CUSTOMER ADVISORY

ADV2002

Label Content Update for FPGA and Power Products

Table 2: Label Sample with “RoHS COMPLIANT”

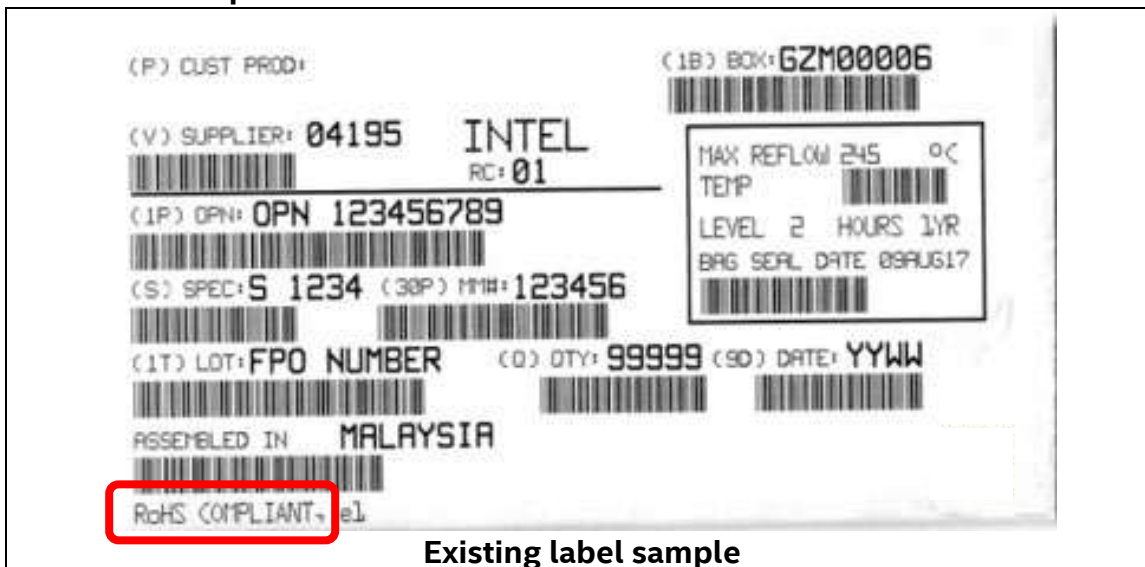
Change From	Change To
"RoHS COMPLIANT" indicated on the lower left of the barcode label	Labels may or may not indicate " RoHS COMPLIANT " on the barcode label. The 2nd level interconnect symbol (e.g. e1) remains printed on the label.

**Sample label where “RoHS COMPLIANT” has been removed.
The 2nd level interconnect symbol (e.g. e1) is still printed on the label.**
